**November 1, 2017**

## **TCMC Emergency Department**

SA # 01593.00

**BID ADDENDUM NO. 1**

1/4" PARTIAL DEMO RCP **FIRST**

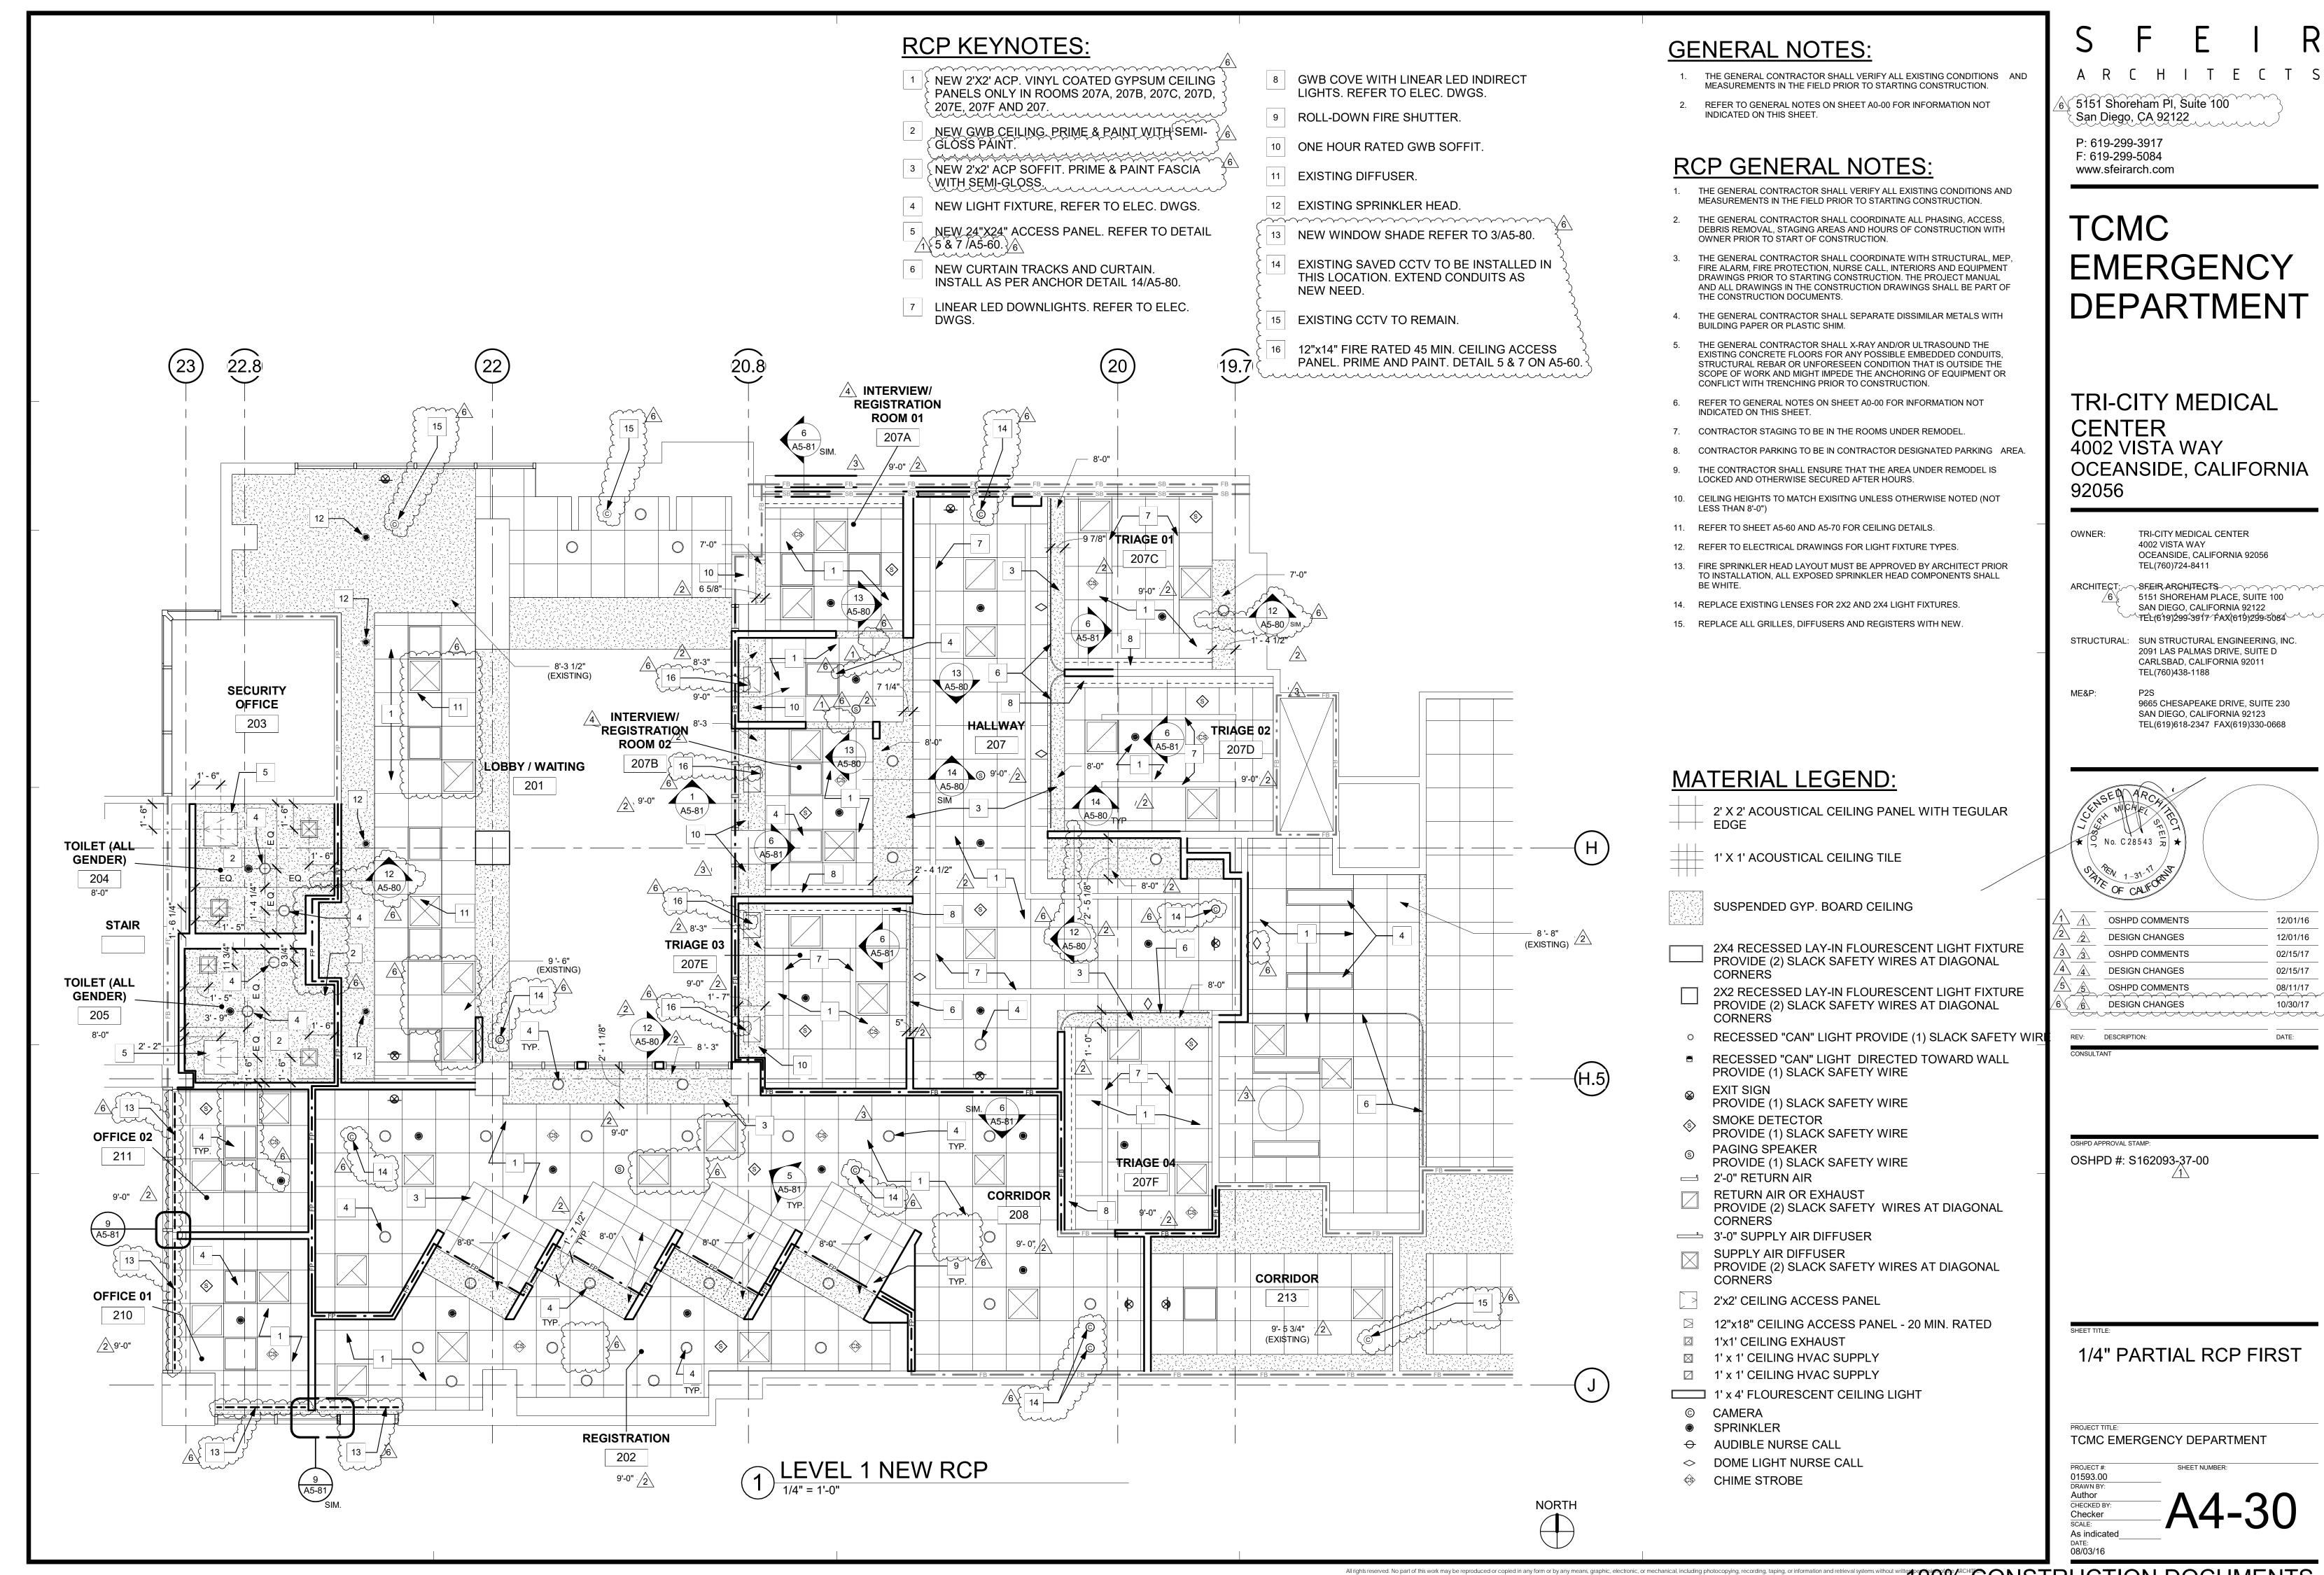
Add the following Keynotes to RCP demolition Keynotes:

"14 – Remove CCTV devices and save for reinstallation."

Add Keynote "14" in Room 211.

Add Keynote "15" in Room 213.

Add Keynote "14" in Room 201 along column Line J.

Add Keynotes "14" South of Room 201.

Add Keynotes "1" in front of Room 203.

Add Keynotes "15" at the North end of Room 201.

1/4" PARTIAL RCP FIRST

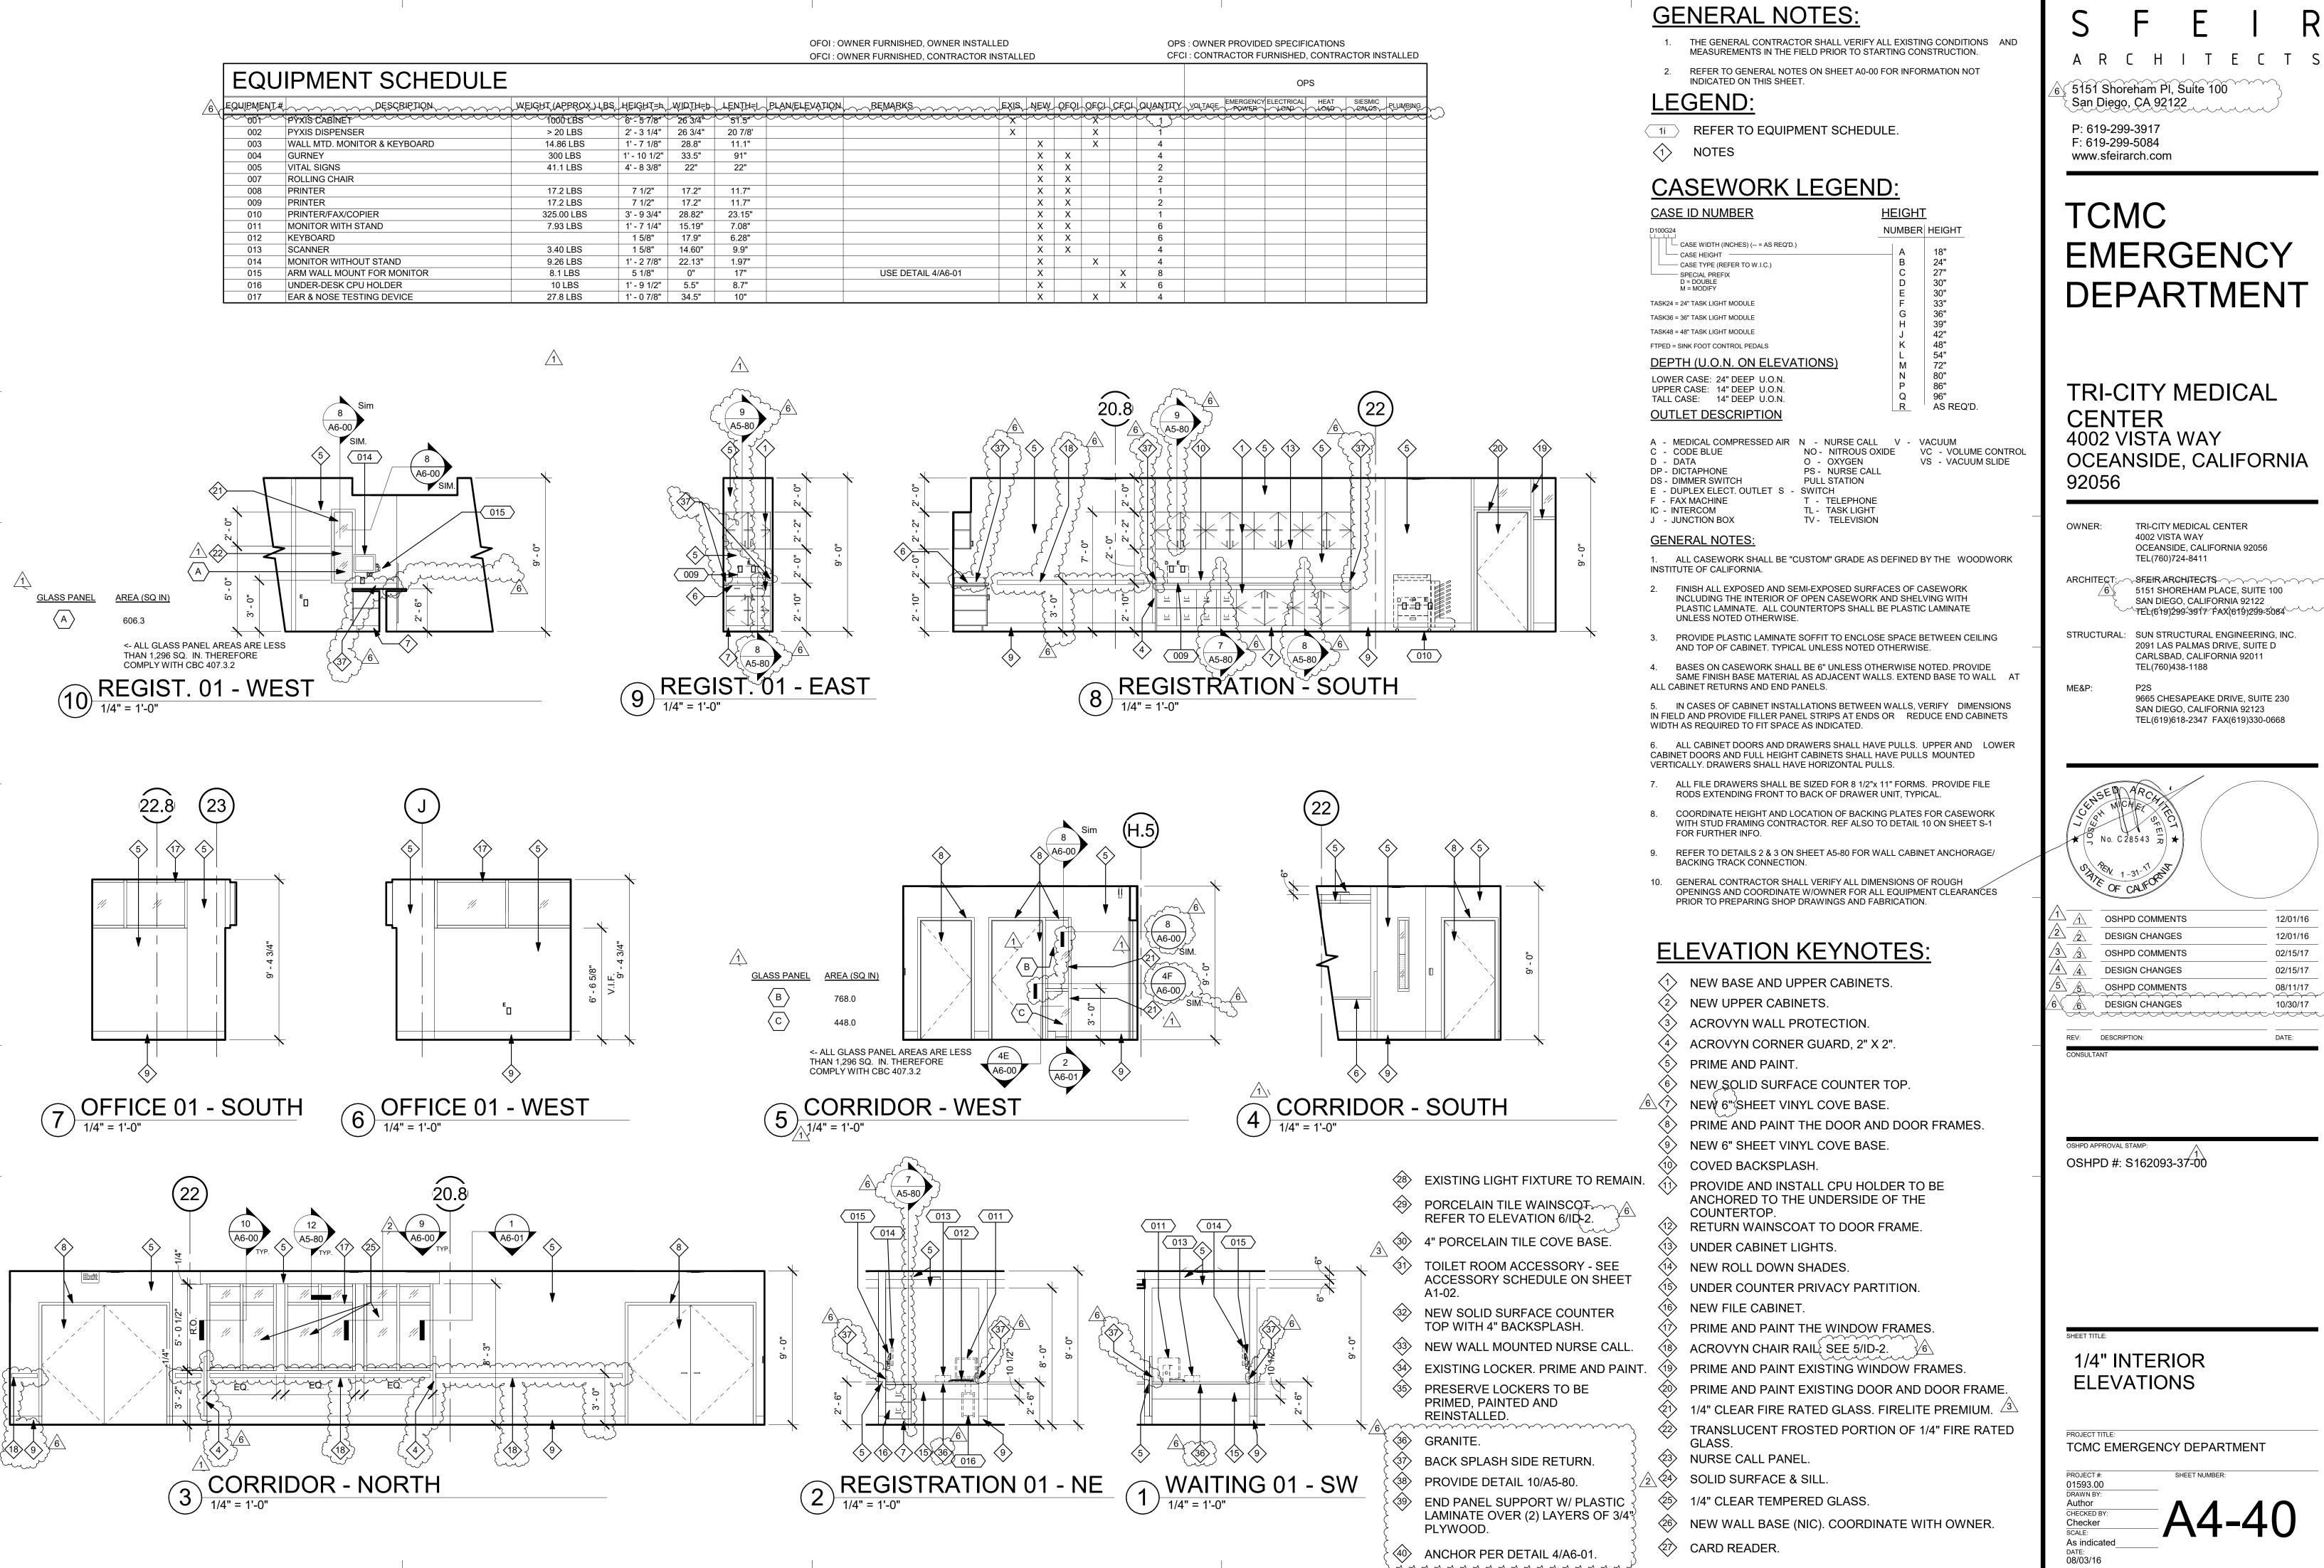
Delete "Prime and Paint with epoxy" and add "Vinyl coated Gypsum ceiling panels only in Rooms 207A, 207B, 207E, 207F, 207, 207D and 207C." in Keynote "1".

Delete "Epoxy Paint" and add "Semi - Gloss" in Keynote "2".

Delete "GWB" and add "2'x2' ACP soffit", delete "with Epoxy Paint" and add "Fascia Semi - Gloss"

Delete "8/A5 - 81" and ADD "5 & 7/A5 - 60." In Keynote "5".

"16 - 12"x 24" Fire rated ceiling access panel. Prime and Paint. Refer to detail 5 && 7 on A5 - 60.

Add section tag 12/A5 – 80 on East wall of Room 207C.

Add Keynote "15" in corridor 213.

Add Keynote "14" in corridor 208.

Add exhaust register in corridor 208.

DOOR AND INTERIOR **OPENINGS SCHEDULE**

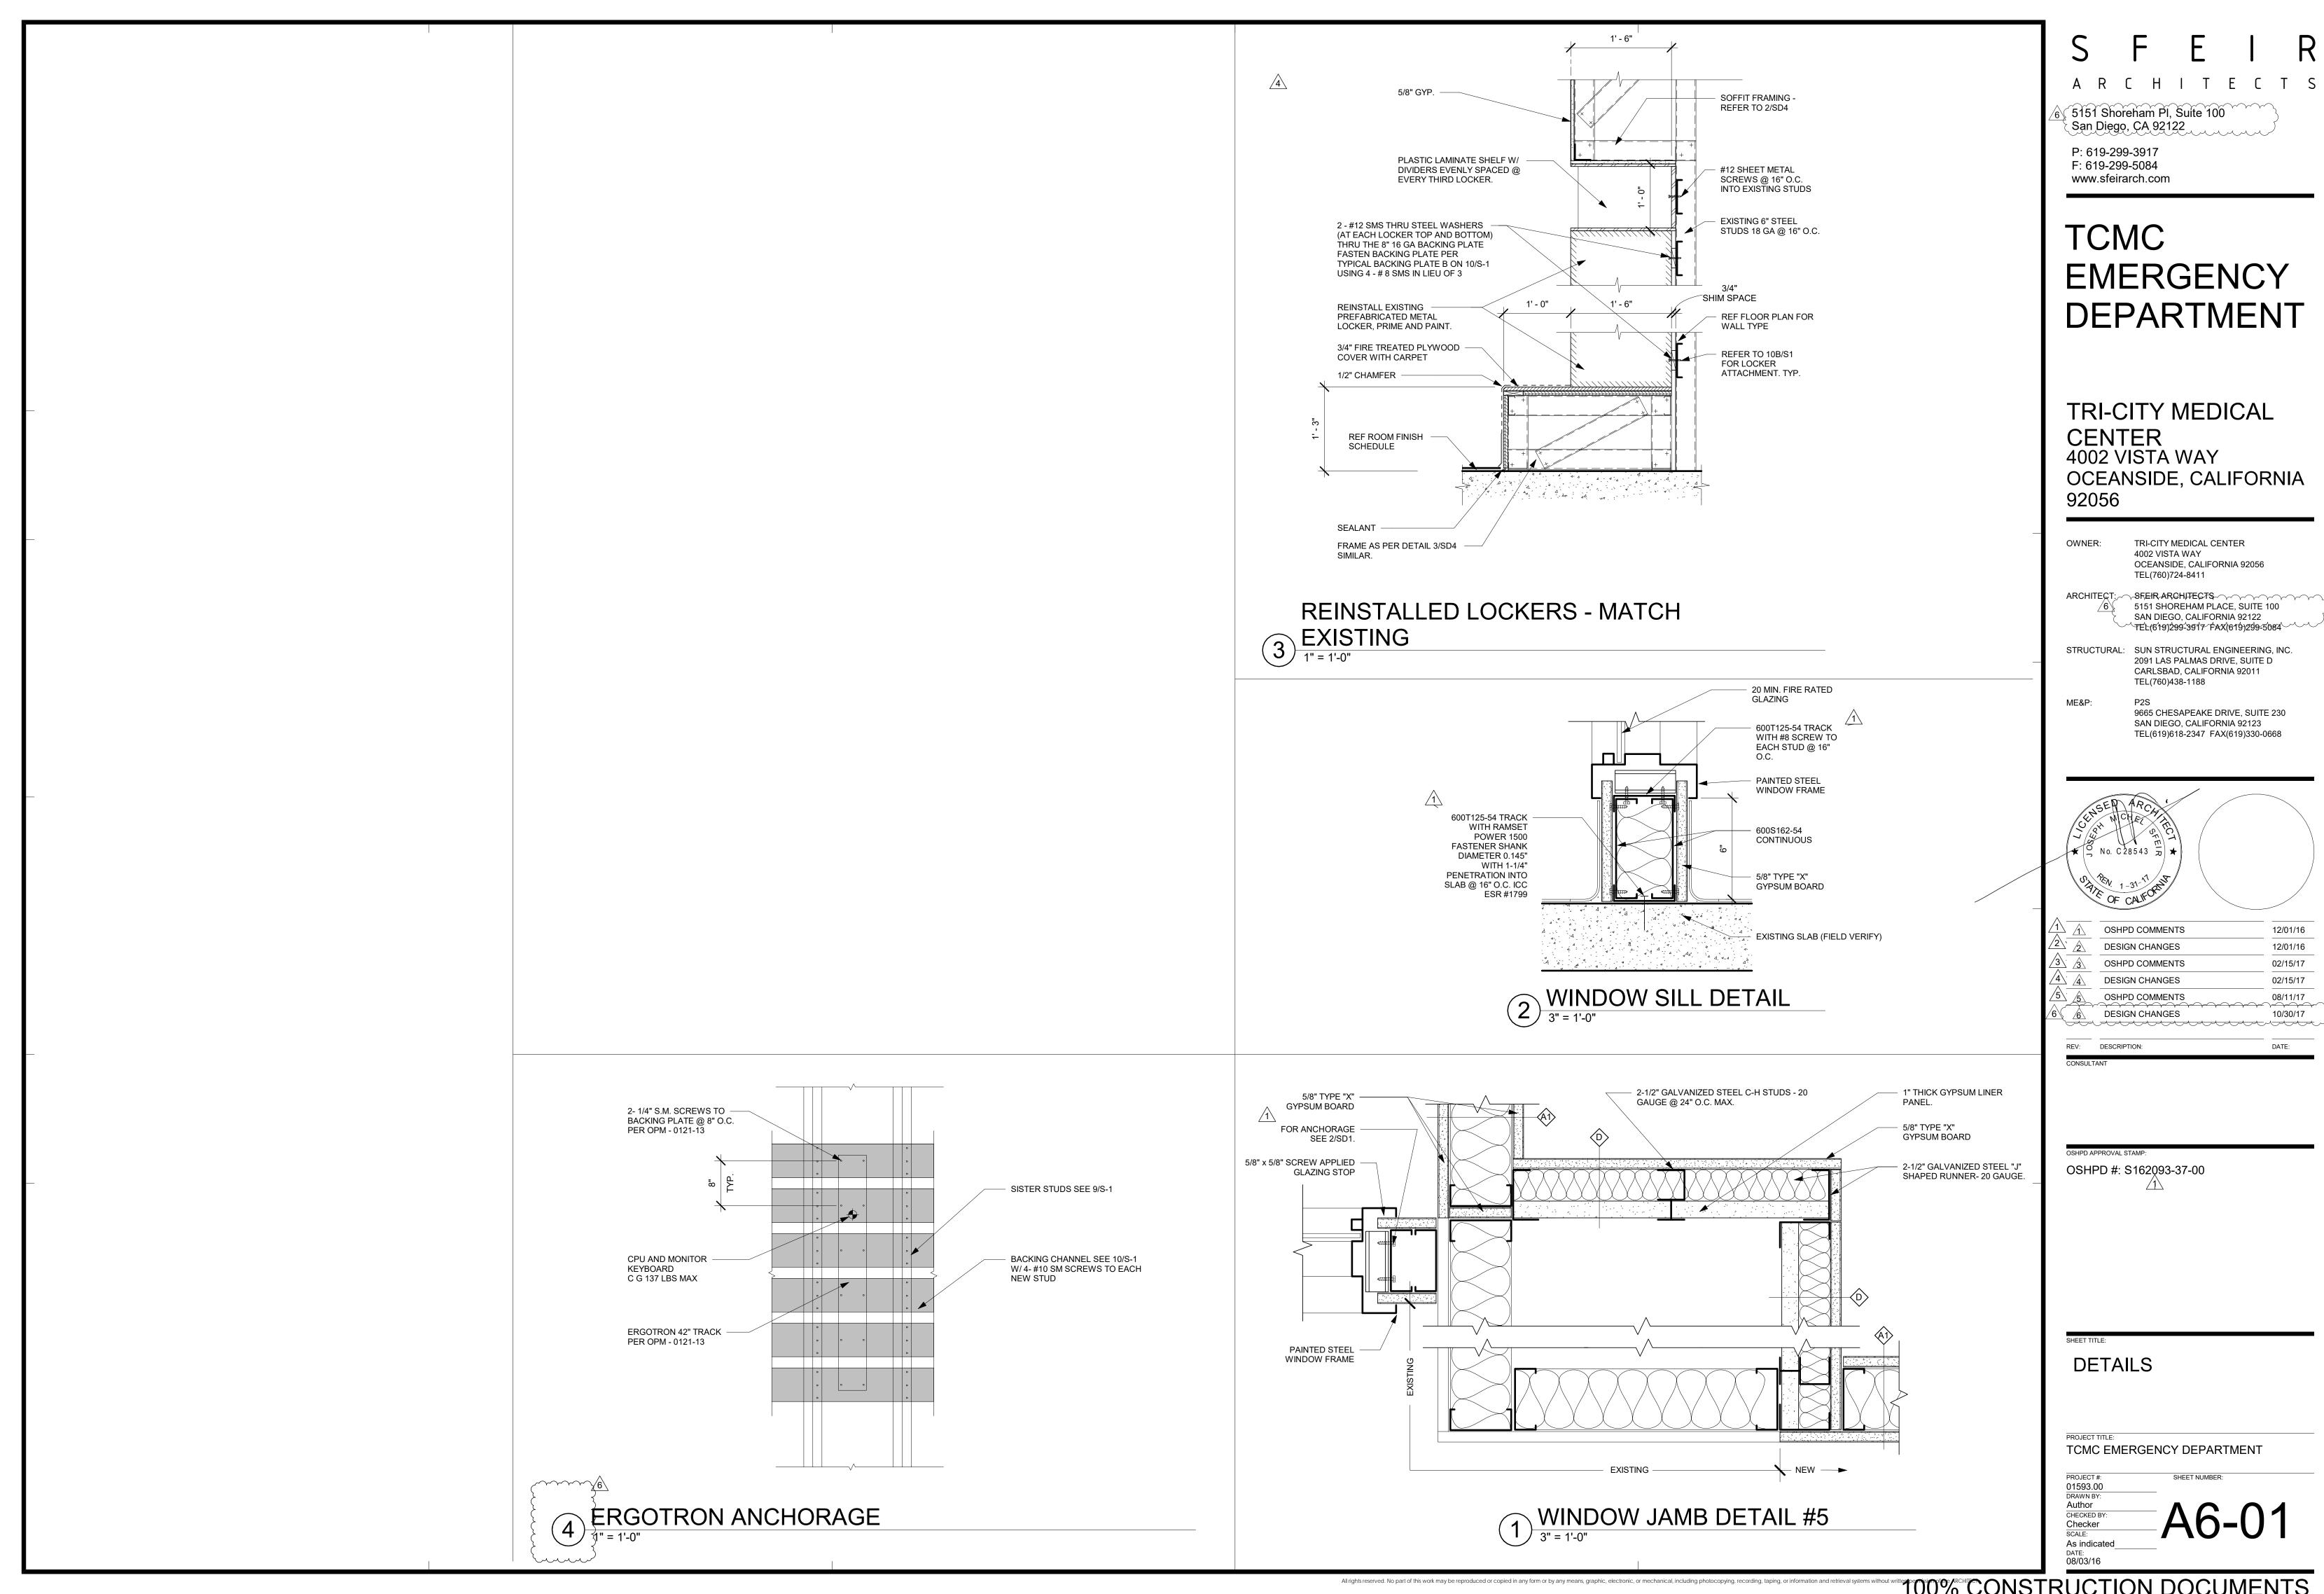
Delete Door Type "1D" for Doors 204 -A & 205-A and add Door Type "1A"
